LiDAR Quality Assurance (QA) Report
Eastern Shore Virginia (ESVA) LiDAR Project
USGS
November 16, 2011

Submitted to:
USGS

Contract:
G10PC00013

The following LiDAR quality assurance report documents Dewberry's fourth review of LiDAR data and derived products for the Eastern Shore Virginia LiDAR Quality Assurance Project. The report identifies areas where issues have been corrected as well as describing some end results of the data that may look unnatural but have been deemed acceptable by project participants. Each tile contains LAS point cloud data classified according to the USGS LiDAR Guidelines and Base Specifications, version 13 classification scheme. The final deliverables also include an ESRI Geodatabase containing hydrographic breaklines and tiled hydro-flattened digital elevation models (DEMs).

Figure 21-Tile S23_3930_10, Delivery 1. Delineation of water body did not correctly follow shoreline, leaving a large area of the feature missing.

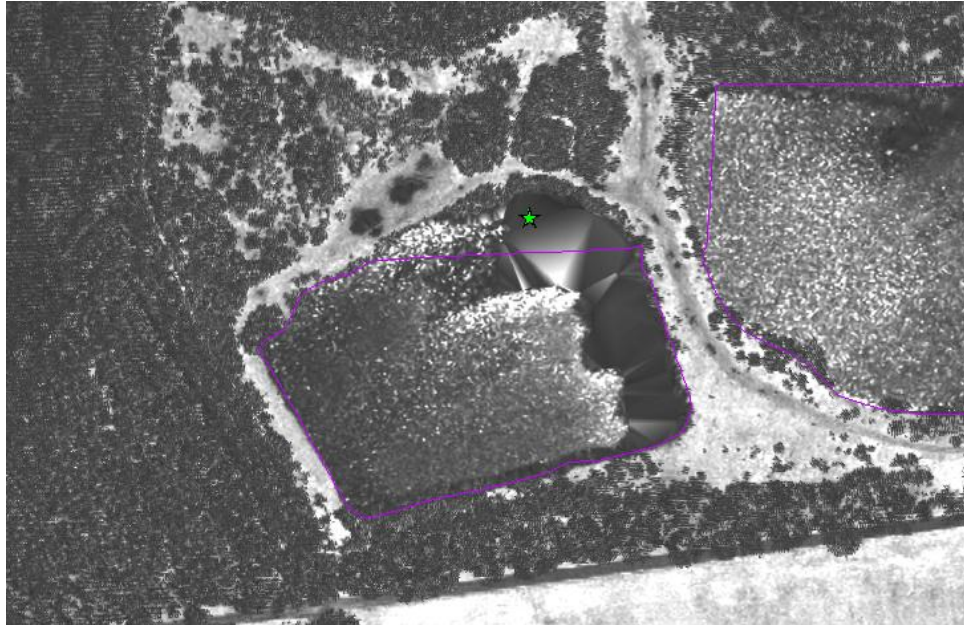
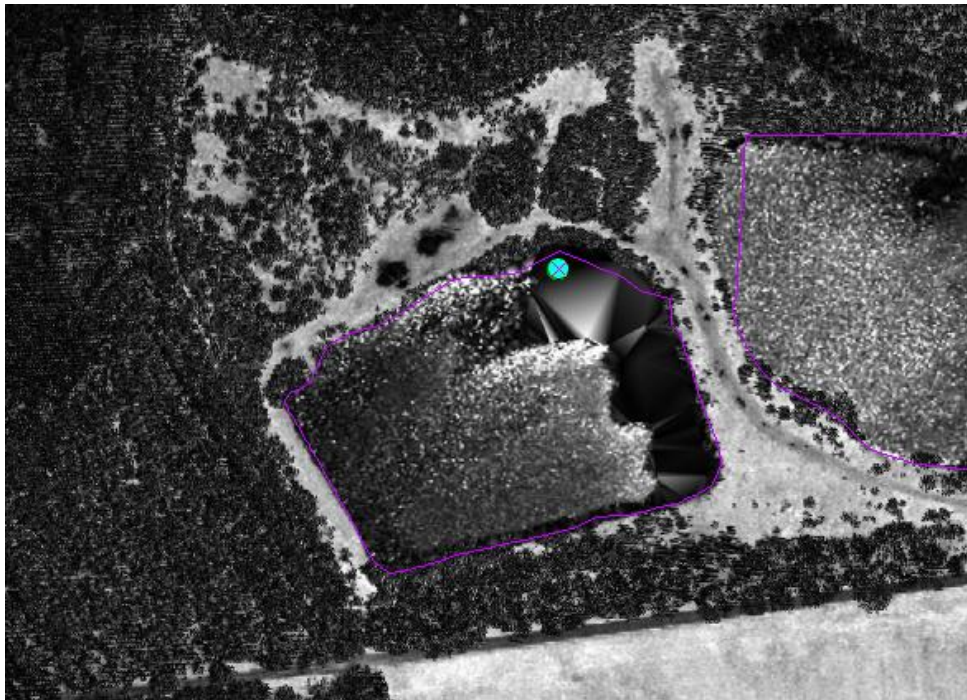
The delineation of features (104) in some areas was identified in the first delivery as not correctly following the shoreline. These features were updated in subsequent deliveries to better reflect the land/water interface at the time of LiDAR collection. An example is shown below.

Figure 22-Tile S23_3930_10, Delivery 4. Delineation of water body has been corrected to fully capture feature.

Figure 23-Tile S23_3858_10, Delivery 1. Unnatural appearance of Inland Stream, shown with blue line. Feature should have been rounded off where it becomes too narrow to meet specifications, so as not to appear to be “cut-off”, or stopped by a man-made structure.

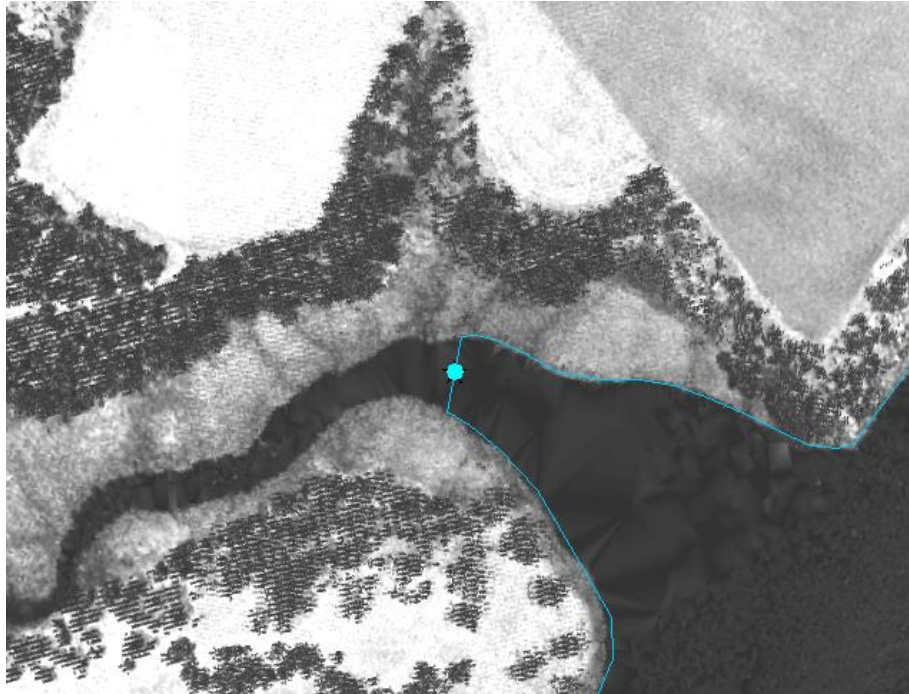
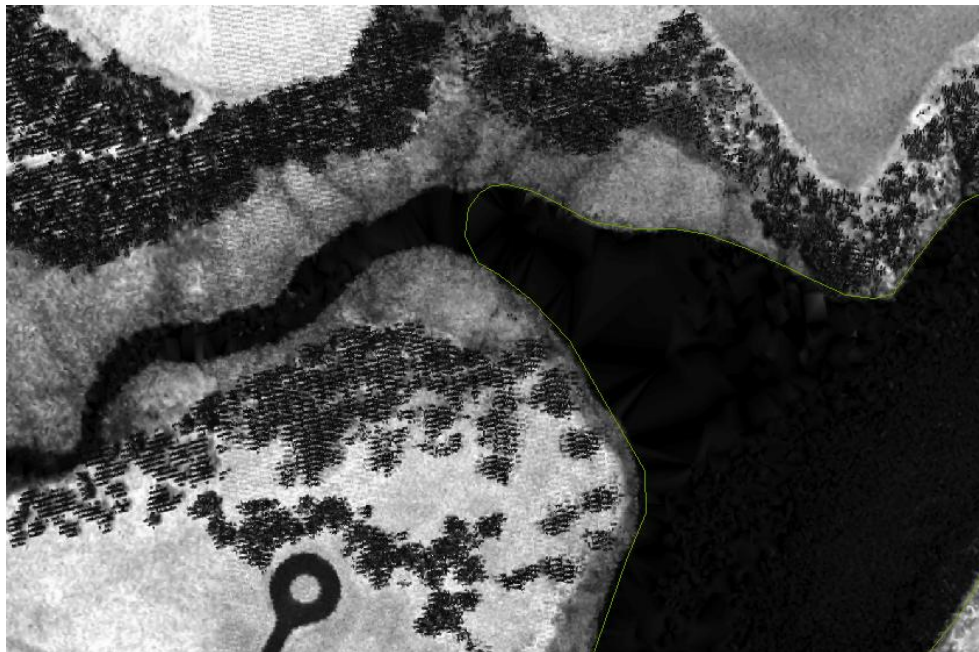
During the first review it was noted that when some features became too small to meet minimum collection requirements, the breaklines (7) were abruptly stopped or appeared “cut off” as if a man-made structure was at that location. These breaklines were corrected to appear more natural and not mistaken for man-made features, such as dams. An example is shown below.

Figure 24-Tile S23_3858_10, Delivery 4. Unnatural appearance of Inland Stream, shown with green line, has been corrected by rounding it off. This feature no longer appears to be “cut-off”, or stopped by a man-made structure.

Figure 25-Tile S23_3845_40, Delivery 1. The incorrect horizontal placement of this feature along the bank was causing sections of it to be digging by several feet. Breaklines need to be adjusted to define the actual land/water interface.

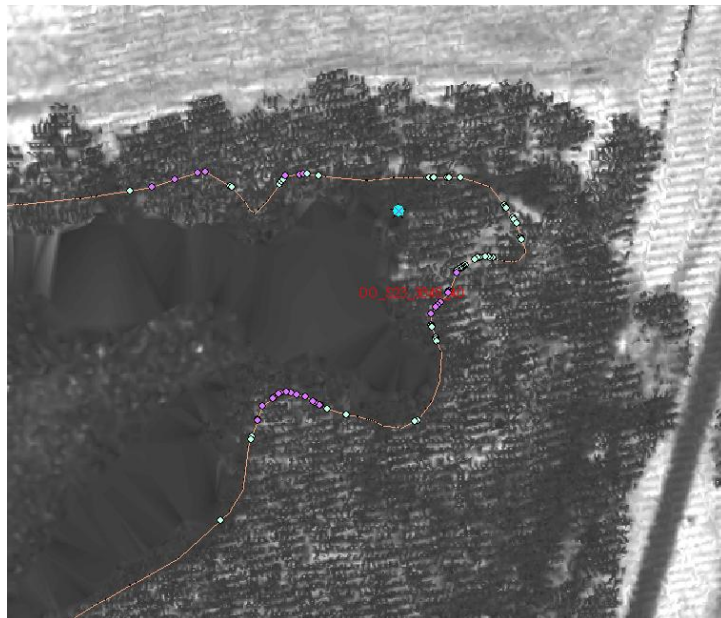
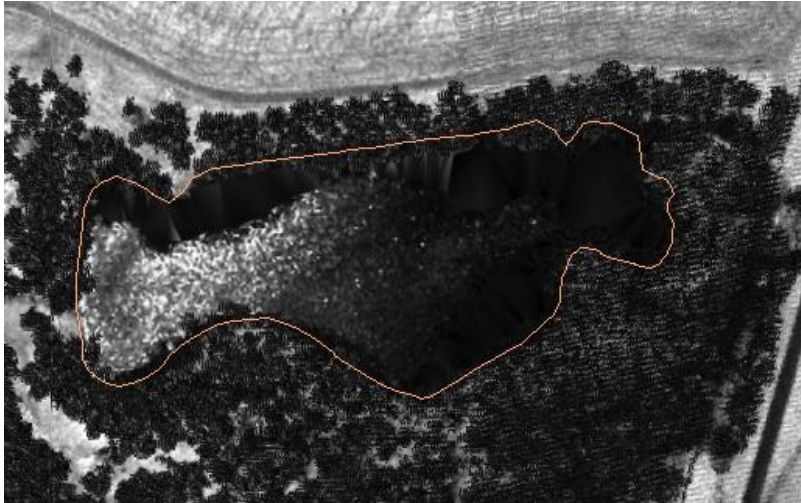
Per USGS specification, all breaklines must be at or just below the surface of the surrounding terrain. To ensure this requirement is met, the ΔZ is reviewed for every vertex. Vertices floating above the surrounding terrain by more than 0.1ft are considered an error as 0.1ft is noticeable in the DEMs. Vertices digging by more than 1ft were also reviewed. Vertices digging due to LiDAR noise, holding pond and lake elevations constant, etc. are not considered to be errors. A few edit calls (23) were placed during the first review for water body features that were digging by several feet due to incorrect horizontal placement. Sanborn corrected these issues in subsequent deliveries by modifying the breaklines to show the actual land/water interface. Elevations for features that were identified as floating (2) or excessively digging (3) in the first review was corrected in subsequent deliveries.

Figure 26-Tile S23_3845_40, Delivery 4. The horizontal placement of this feature was corrected to show the actual land/water interface.

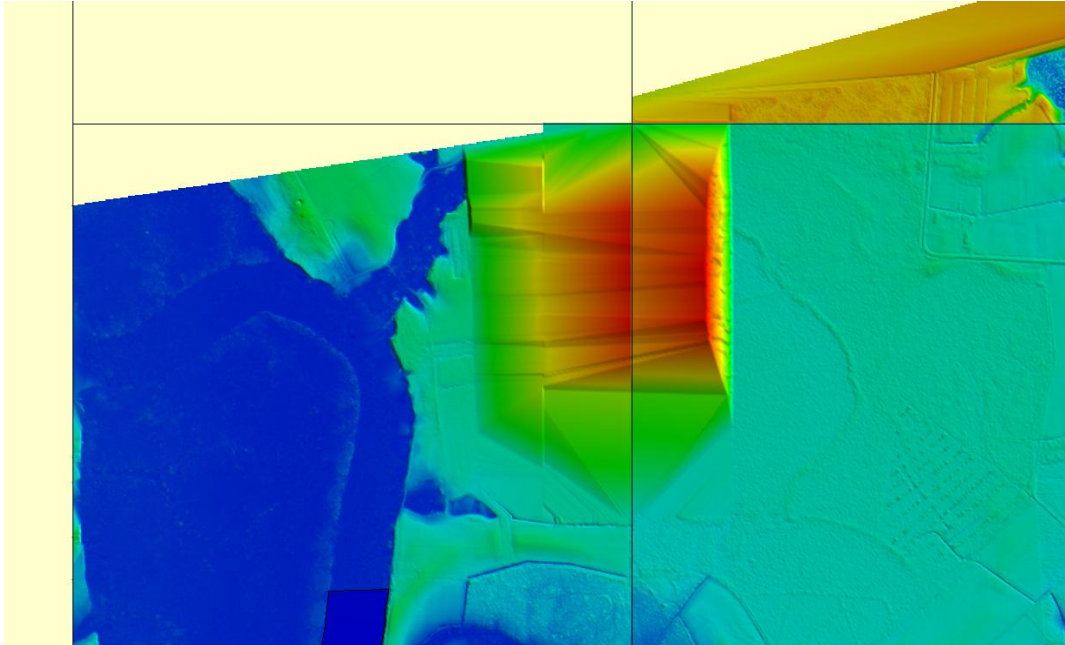
The DEMs have coverage to the full extent of the project boundary. Data was not clipped to this boundary, but extends well beyond the boundary. Data extending beyond the boundary may not always have full coverage and DEMs may not be flattened in these areas outside of the boundary. Some of this data outside of the boundary may have coverage gaps and be unusable. Sanborn is not required to clip the data. EROS has elected to receive all data and to perform the final clipping so that they control the final clipping boundary and selection of data that will ultimately be used in the NED program. An example of unusable data located outside of the project boundary is shown below.

Figure 27-DEM_S23_3910_10, all deliveries. Some areas outside of the project boundary may be unusable. The identified area is a coverage gap well outside of the required project boundary, with an anomalous high ridge along the eastern side of the gap. This particular area is unusable even though it was delivered with the final DEMs. EROS will perform the final clipping of the data.

Figure 28-DEM_S23_2652_20, Delivery 1. Multiple artifacts with varying elevations were located within Tidal Waters.

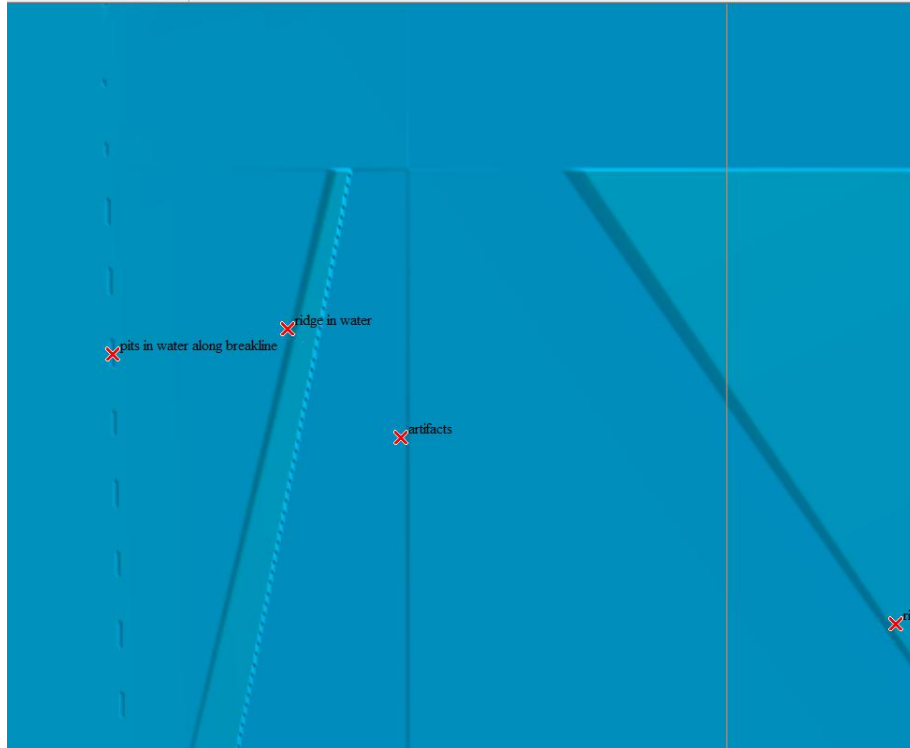
Numerous artifacts (315) were identified within water features in the first delivery. Sanborn modified their production process and the DEMs are now flat from bank to bank. Examples are shown below.

Figure 29-DEM_S23_2652_20, Delivery 4. The only elevation change in the water of this tile occurs along the flight line from tidal variations. This step is an acceptable way to show elevation change in water. The water is flat from bank to bank.

Figure 31-DEM_S23_2759_20 and DEM_S23_2759_30, Delivery 4. Now, the only elevation change in the water of these tiles occur along the flight line from tidal variations. This step is an acceptable way to show elevation change in water. The water is flat from bank to bank.

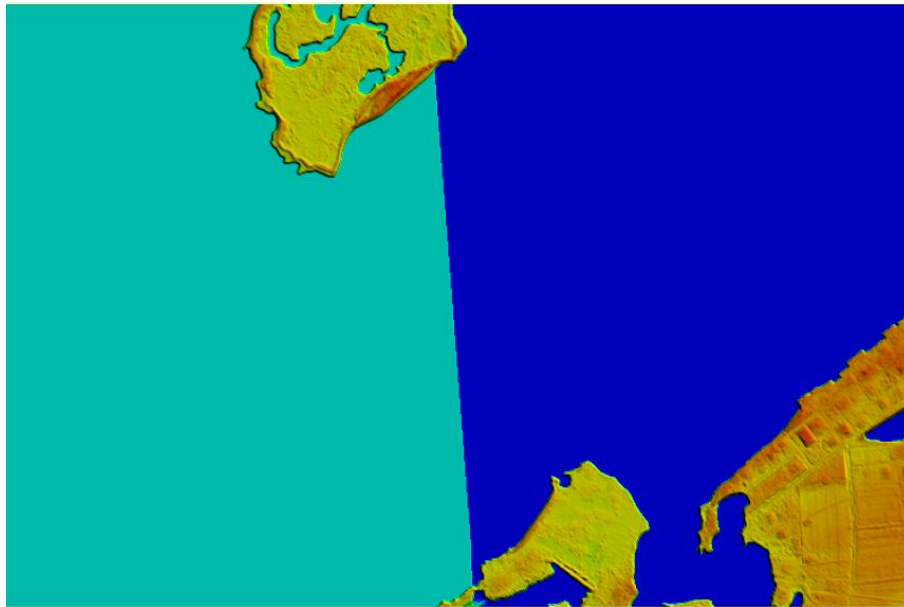
Figure 30-DEM_S23_2759_20 and DEM_S23_2759_30, Delivery 1. Multiple artifacts with varying elevations were located within Tidal Waters.

Figure 32-DEM_S23_3829_10, delivery 1. Tidal waters were floating above the surrounding terrain.

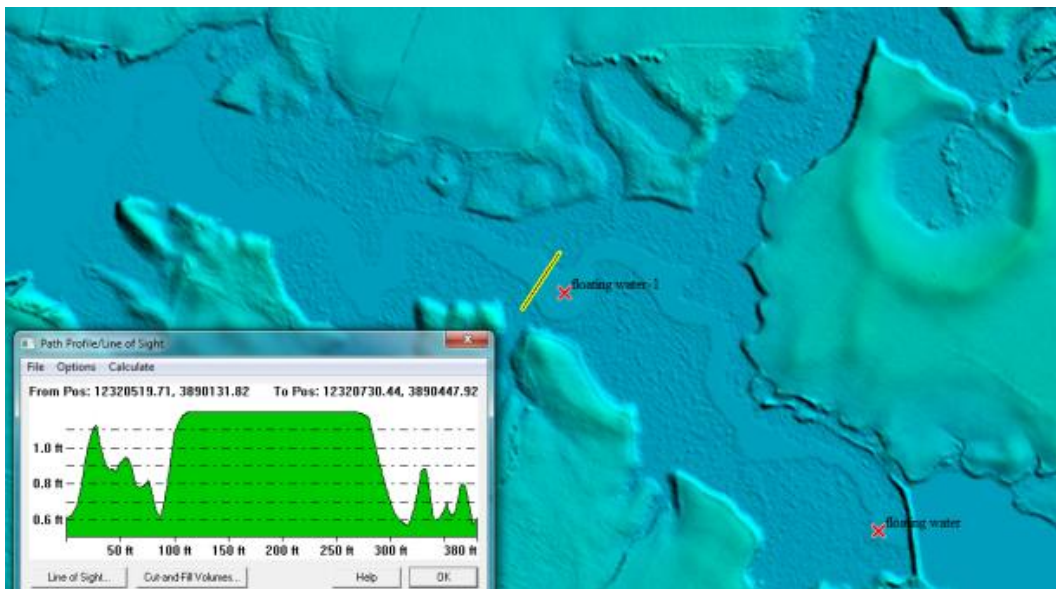
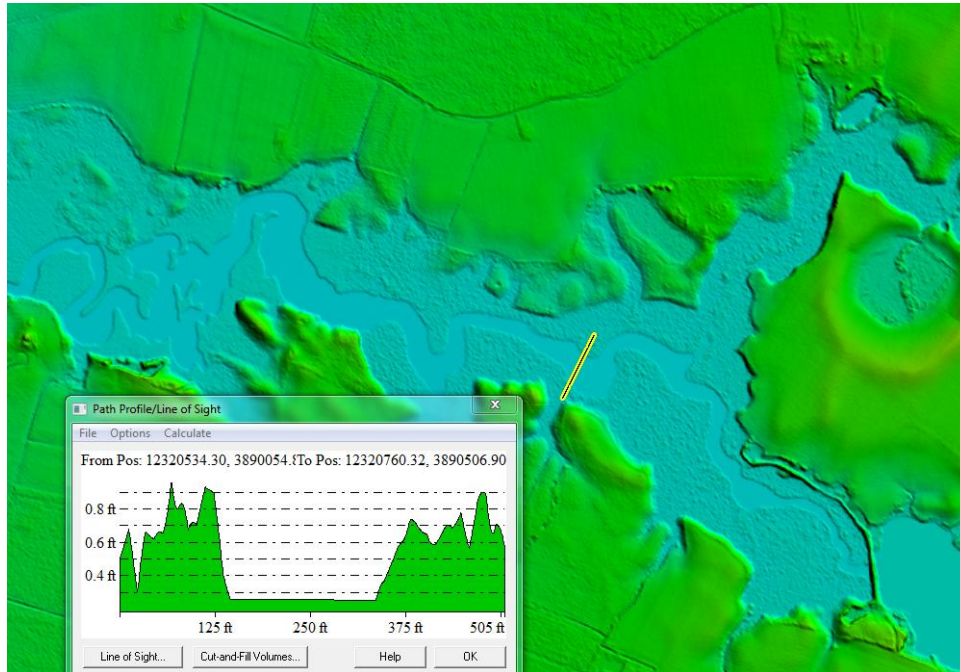
A few features (9) were identified in the first delivery as floating in the DEMs. These features were adjusted to be at or below the surrounding terrain. An example of the corrections is shown below.

Figure 33-DEM_S23_3829_10, delivery 4. Tidal waters that were floating above the surrounding terrain have been corrected and are now at or below the surrounding terrain.

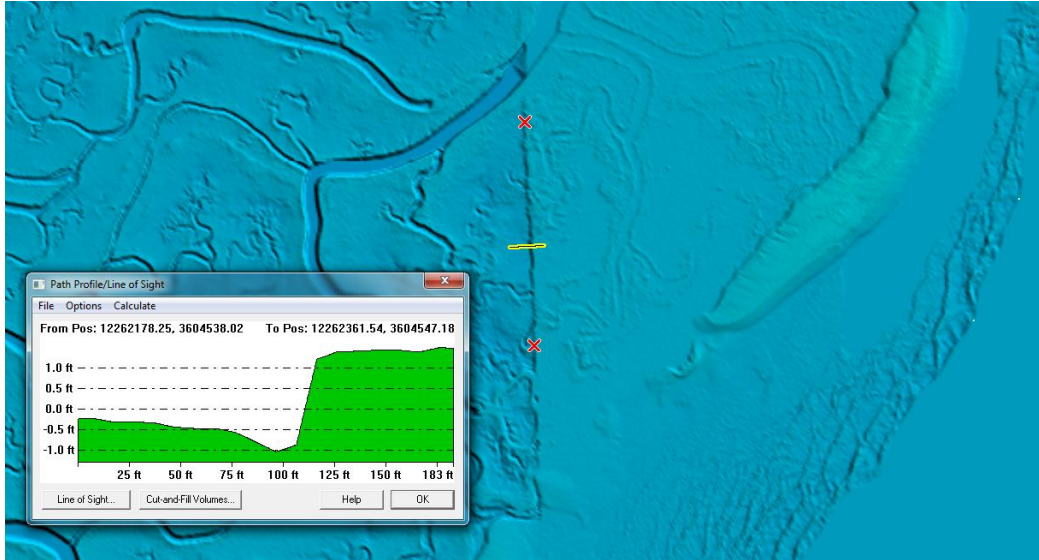
Numerous edit calls (23) were placed in the first delivery where flight line ridges between two adjoining swaths exceeded 12 cm or 0.4 ft as outlined in the Quality Plan. These issues were corrected when Sanborn re-calibrated the LiDAR data. A few flight line ridges were identified in previous deliveries. Most of these were corrected when Sanborn re-calibrated the LiDAR data. However, varying water levels in marsh or vegetated areas can affect the return of LiDAR signals to the sensor. Some LiDAR signals may show a greater absorption in wetter marsh areas compared to drier marsh areas. This greater absorption before the LiDAR signal is transmitted back to the sensor can translate into lower elevations. Or, some LiDAR signals may reflect off of the thin water layer covering or partially covering an island rather than reflecting off of the “ground” surface. The LiDAR could potentially show different responses between adjoining flight lines in marsh or wet areas such as tidally exposed islands, depending on the tide levels. Some of this variance in the LiDAR return signals may result in an elevation step between adjacent flight lines. These flight line ridges that occur in marsh like land cover types were not held to the USGS 10 cm relative accuracy specification for adjoining swaths as the flight line ridges do not occur over “true” ground. An example of flight line ridges that may still appear in the dataset is shown below.

Figure 34-DEM_S23_2660_20 and DEM_S23_2660_10, All deliveries. Flight line ridges are more prominent on tidally exposed ground. These tidal flats can be very marshy with varying levels of water present. As these areas are not “true” ground, they were not held to the same relative accuracy specifications outlined for actual ground.
